**Marion County
Board of County Commissioners**

**PLANNING & ZONING SECTION
STAFF REPORT**

Public Hearing Dates	P&Z Date: 05/27/2026	BCC Date: 06/16/2026
Case Number	260608ZP	
CDP-AR	PL PUD -000543-2026	
Type of Case	PUD Amendment with Concept Plan: Request to 1) Increase the number of proposed lots from 240 to 261 but not to exceed 321 lots; 2) Modify the number of units assigned to each of the three lot dimension options; 3) modify amenities; 4) Reduce the minimum front setback requirement from 25' to 20'	
Owner	Jax Road, LLC.	
Applicant	Tillman and Associates Engineering, LLC	
Street Address/Site Location	5823 NE Jacksonville Rd., Ocala, FL 34479	
Parcel Number(s)	14973-000-00 & 14971-001-00	
Property Size	±79.21 acres	
Future Land Use	Medium Residential (MR)	
Existing Zoning Classification	Planned Unit Development (PUD)	
Overlays Zones/Special Areas	Urban Growth Boundary (UGB), Primary Springs Protection Overlay Zone (P-SPOZ)	
Staff Recommendation	Approval with Conditions	
P&Z Recommendation	TBD

Figure 2 - Proposed PUD Master Plan (260608ZP)

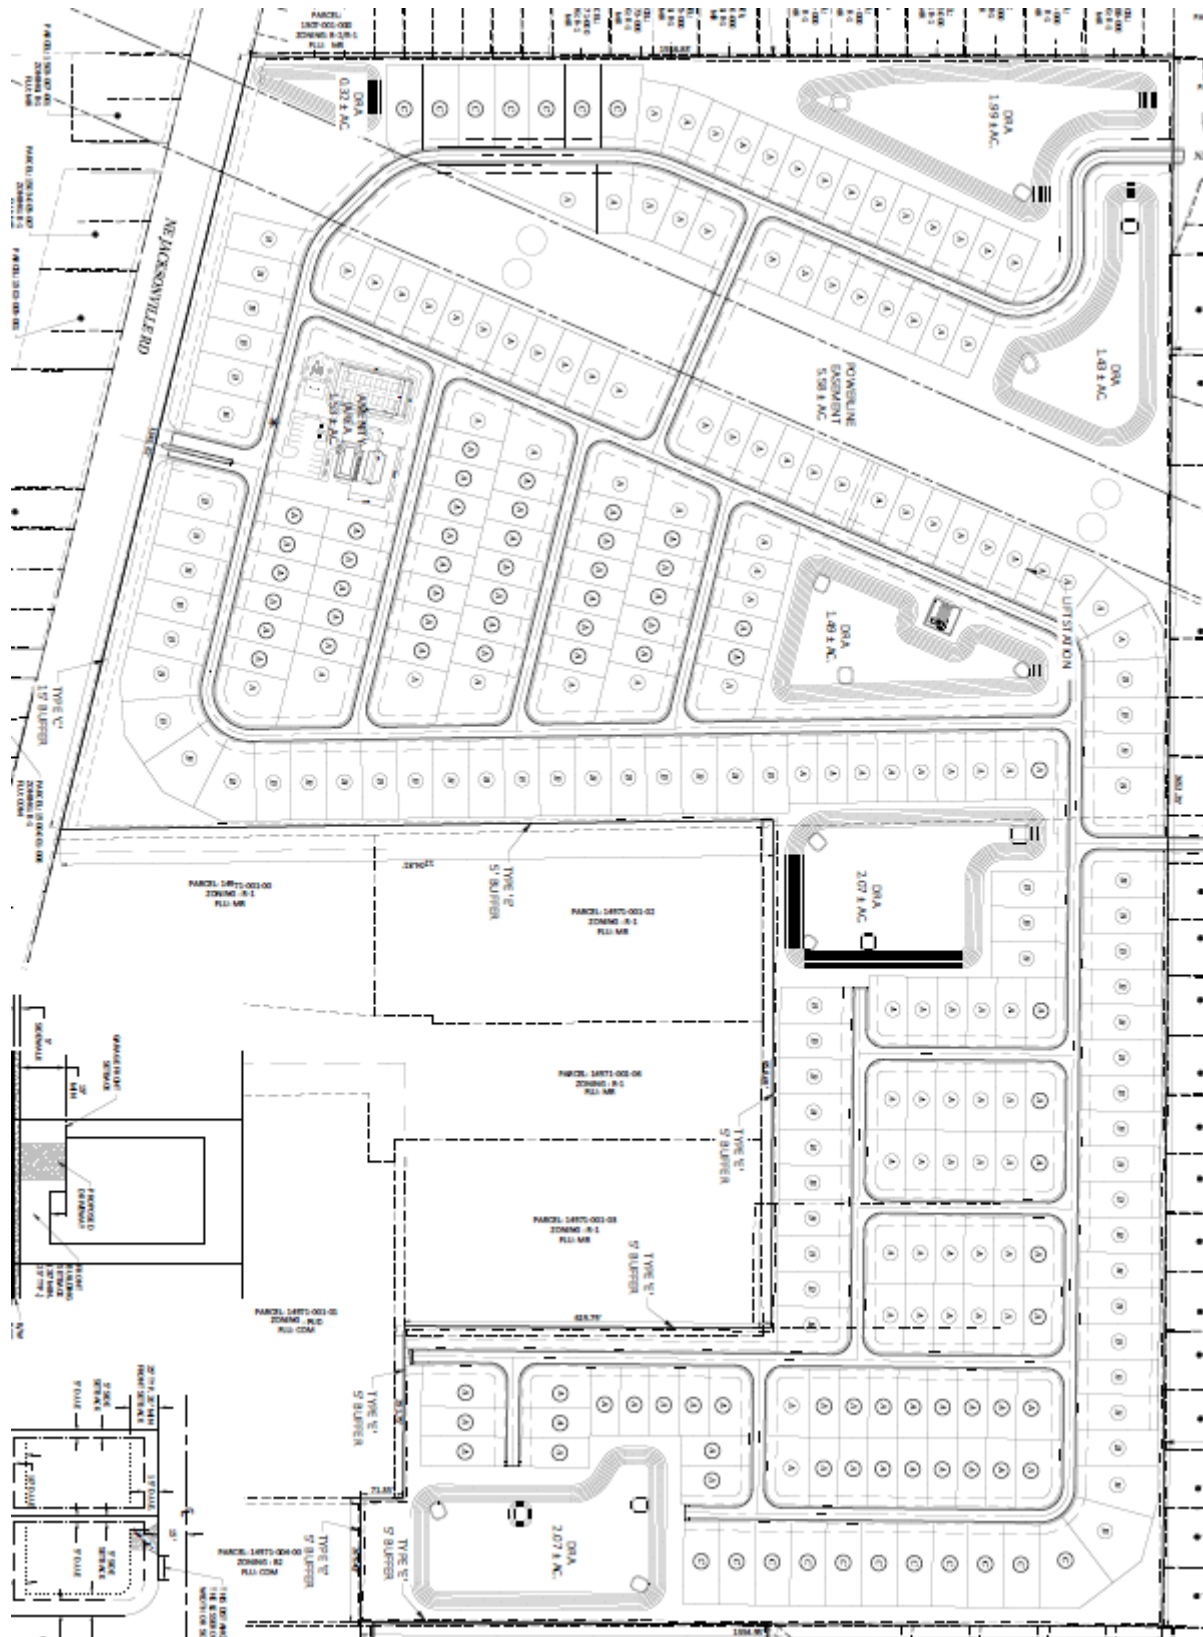
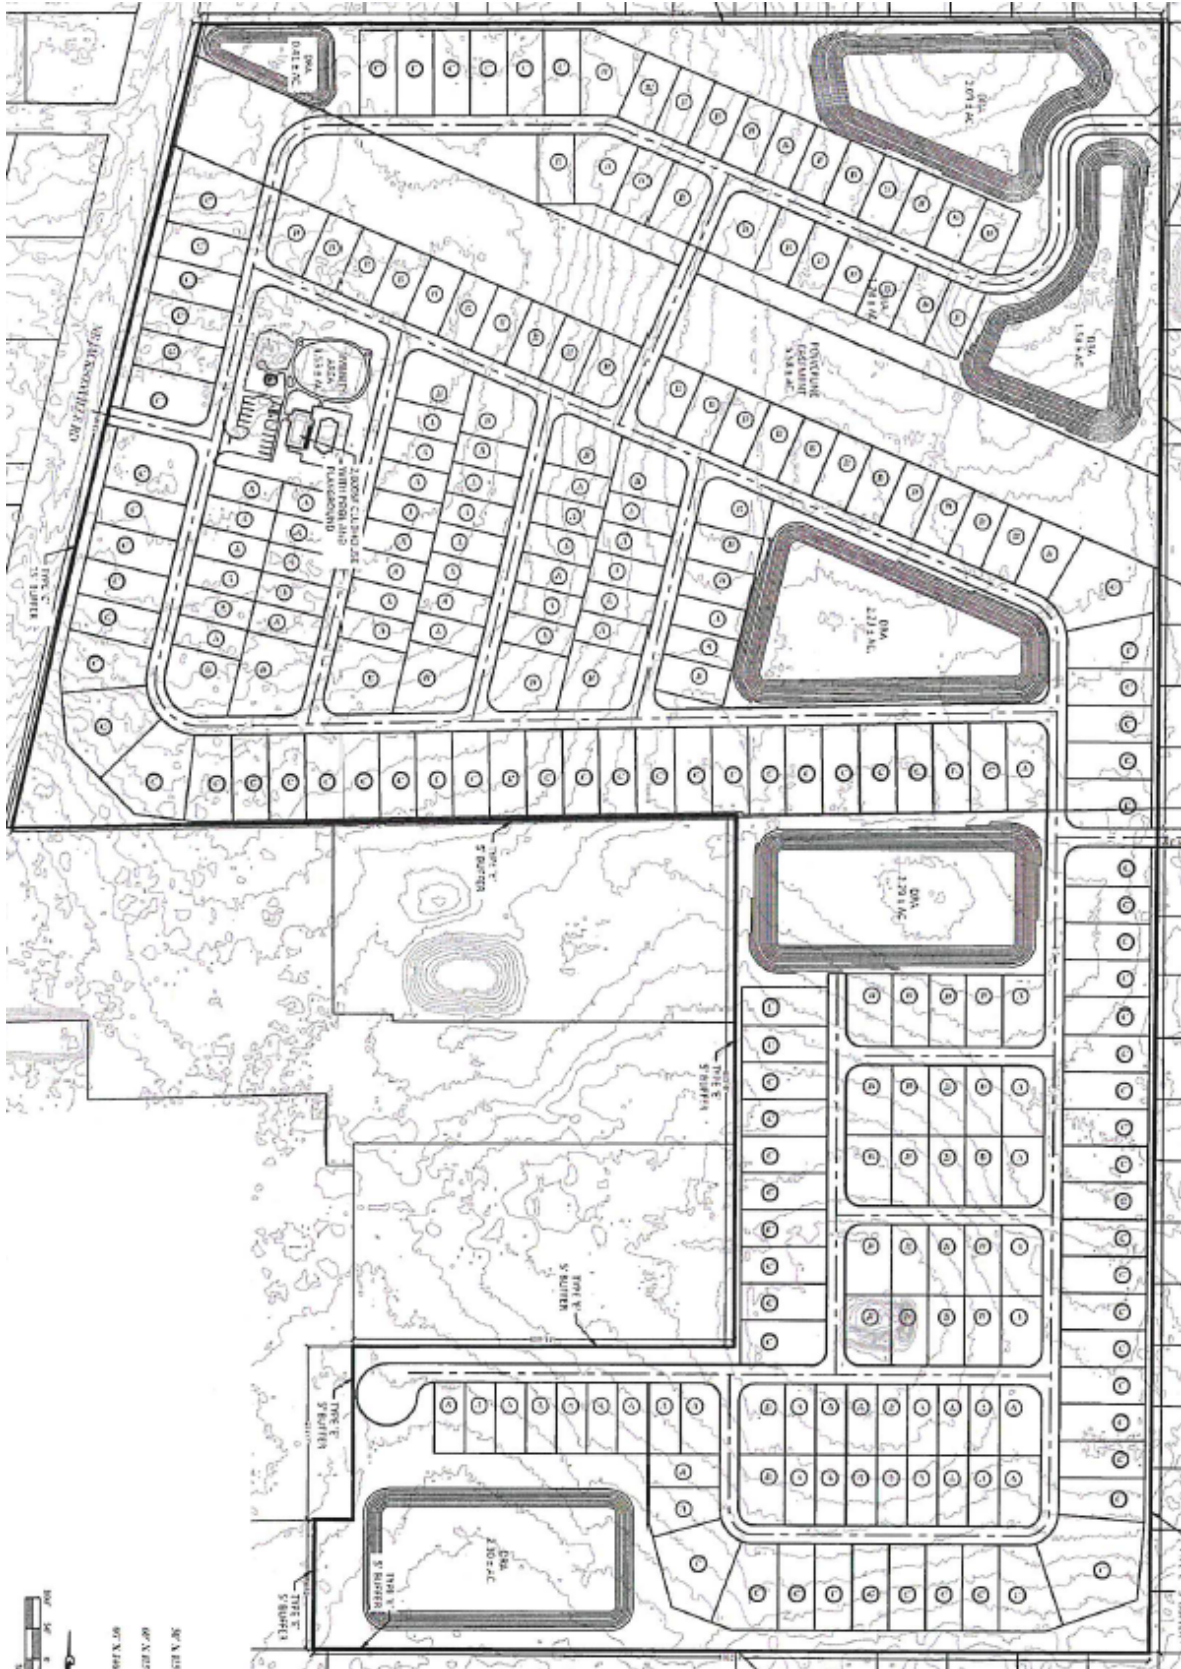
1. **An increase to the number of proposed lots:** The 2022 conceptual plan approved showed a total of 240 residential lots; however, the applicant requested approval for up to 321 residential lots. The requested approval is for 261 residential lots – but not to exceed 321 residential lots,.

2. **Modifications to the number of lots for each of the three lot dimension options:** The 2022 conceptual plan approved the following: 72 units at 50'x115', 81 units at 60'x115', and 87 units at 60'x140' for a total of 240 units. The updated concept plan proposes the following: 177 units at 50'x115', 66 units at 60'x115', and 19 units at 60'x140' for a total of 262 units. The application and concept plan differ by one lot.

3. **Modify Amenities:** The approved 2022 concept plan showed a 1.53-acre amenity area that included a 2,000 s.f. clubhouse with pool and playground and an activity field. The amenities modification includes the following items: Pickleball (activity) courts, a limited covered/shaded Playground Area with swing set and equipment, and a designated activity field.

4. **Reduce front setback requirement from 25' to 20':** The previously approved concept plan from 2022 required a 25' minimum front setback. The amended request is for a 20' minimum front setback.

The current PUD proposal seeks an increase in the number of single-family lots from the previously approved 240 units to 261 units; an increase of 21 lots. The parcel has a Medium Residential (MR) land use that allows 1-4 du/ac. At 79.21 acres, the land use could accommodate between 80 – 316 units. While the 261 units being sought fall within the range of allowable density, the additional request of, "but not to exceed 321 units," does not.

The request must be amended to be, “Increase the number of proposed lots from 240 to 261 but not to exceed 316 lots.” This would put all proposed figures within the range of possible density relative to the size of the property.

1. **[Modified]** The PUD shall consist of 261 single-family detached residential (SFR) dwelling units, up to a maximum total of 316 units, provided consistent with the Concept Plans listed development standards.
